# Groundwater Application Review Summary Form

Application # G- 18808

**To:** Kristopher Byrd, Well Construction and Compliance Section Manager  
**From:** Joel Jeffery, Well Construction Program Coordinator  
**Subject:** Review of Water Right Application G-18808  
**Date:** July 12, 2019

TO: Water Rights Section Date 6/20/2019  
 FROM: Groundwater Section Benjamin Scandella, Jen Woody  
 Reviewer's Name  
 SUBJECT: Application G-18808 Supersedes review of n/a  
 Date of Review(s)

Figure 2. Well Location Map

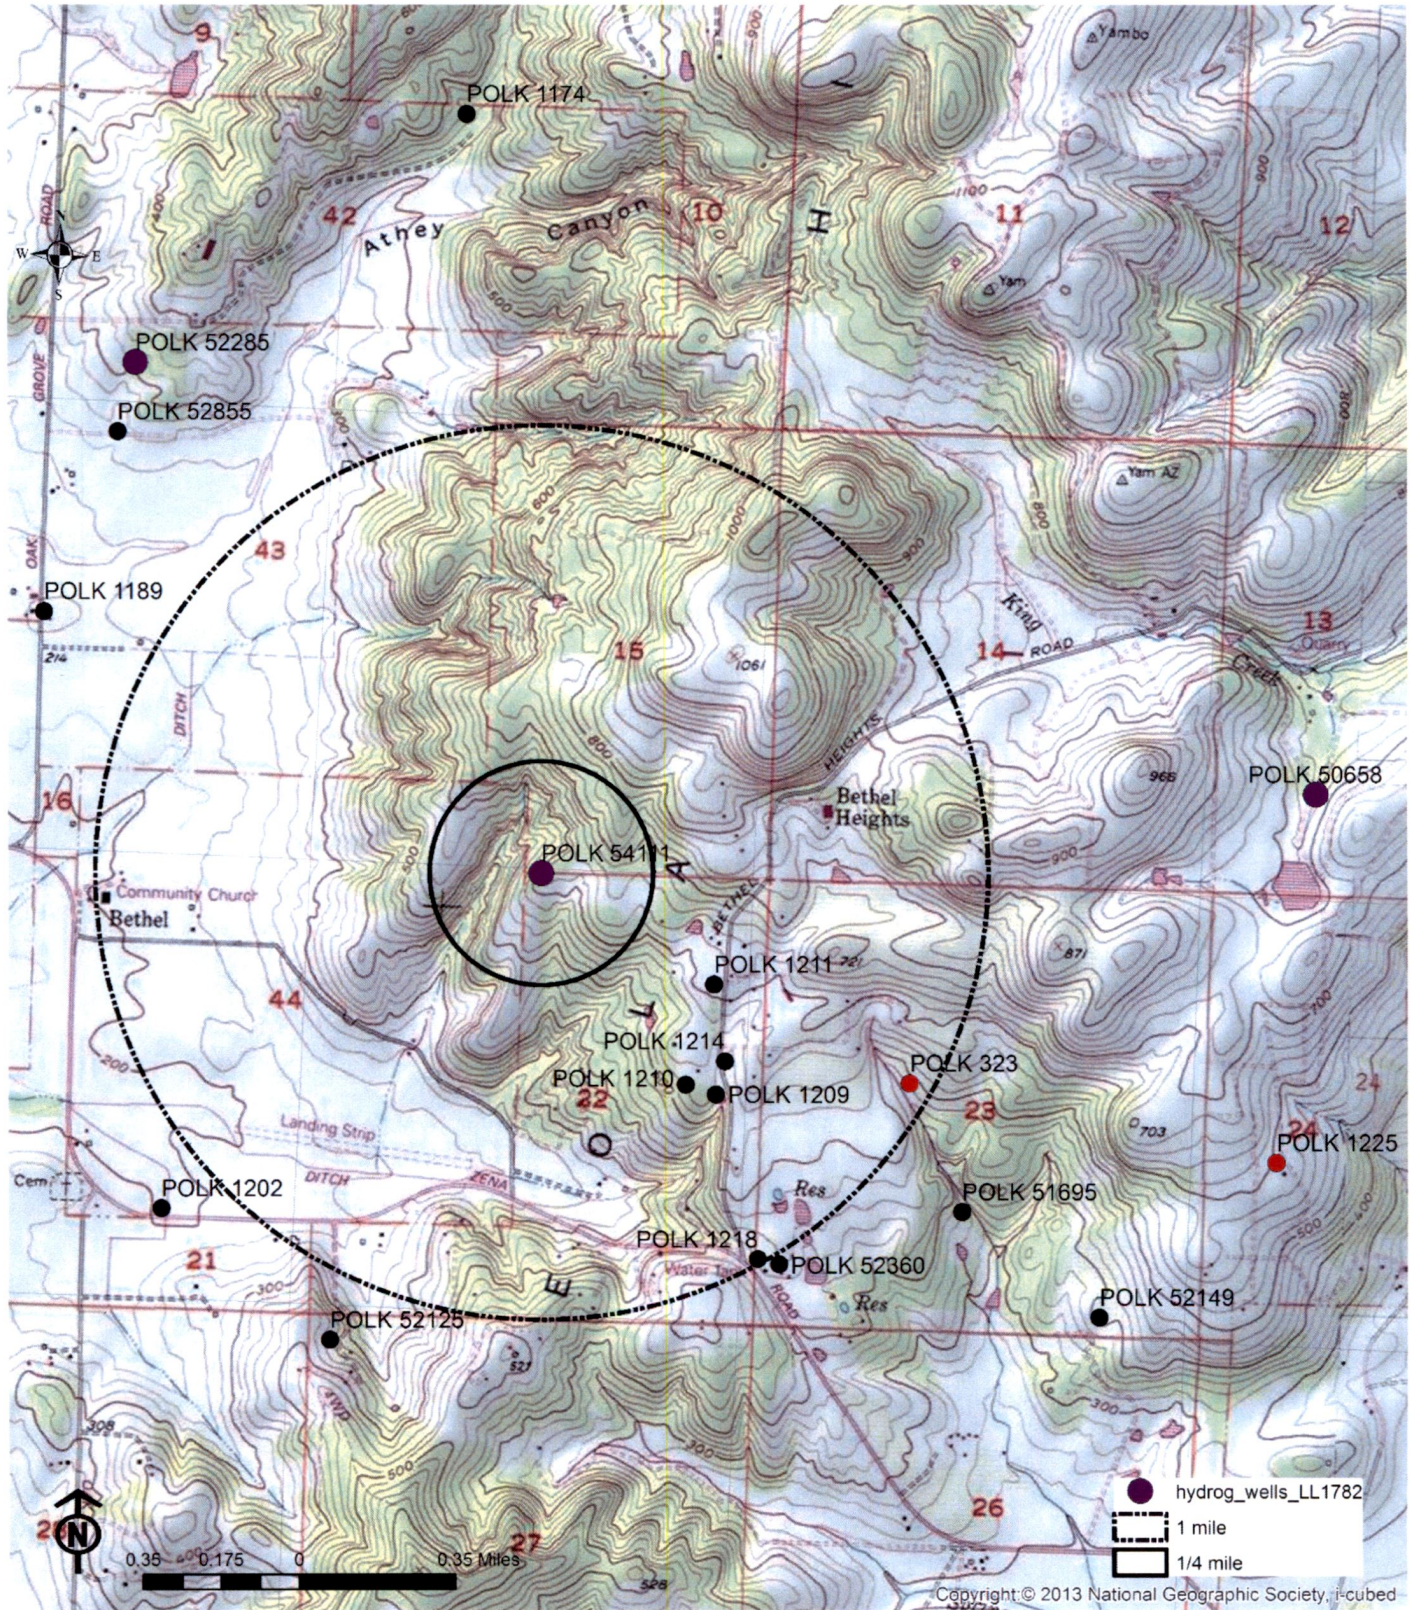
A6.  **Well(s) #** POLK 54111 tap(s) an aquifer limited by an administrative restriction.  
 Name of administrative area: Eola Hills Groundwater Limited Area (690-502-0200)  
 Comments: While the subject well lies geographically within the Eola Hills Groundwater Limited Area, it does not access a basalt aquifer, so the administrative restrictions do not apply.
